**PROJECT:** Pace Manatee

## RFP Addendum #2 RFI Q&A

## **ITN BIDDING QUESTIONS**

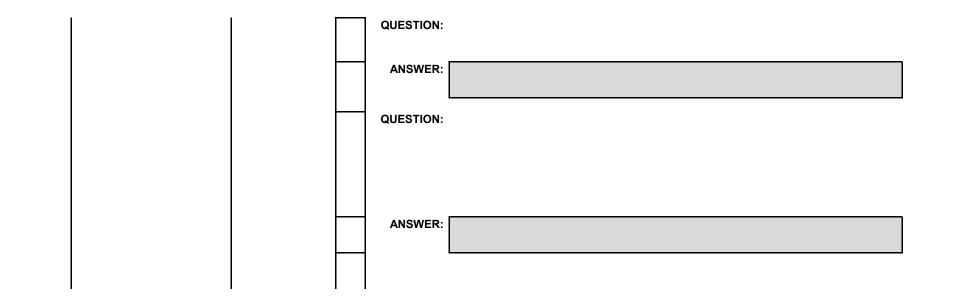
ANSWER: C	Correct, 12" deep.
2/22/2024	Countertop	A1.1, A7.0	24	1	A1.1 indicates transaction counterto at open window for service between 126 Kitchen and I30. Elevation on 4/A7.0 is unclear whether a transaction top is to be installed at that ocation. Please confirm top and top type.
					Provide 12" wide countertop in opening between 126 and 130. (no window) match same naterial used in kitchen.
2/22/2024	Stainless Steel Panels	A7.0, A8.0	25	K ir	8/A7.0 indicates FRP wall panels and stainless steel wall panels on south wall of 126 Kitchen. A8.0 indicates FRP panels on south and east walls of kitchen but does not ndicate wall finish for west wall adjacent to burner stove. Please advise if east wall shoud recieve stainless steel wall panels.

ANSWER: E	East wall to receive stainless wall panels.
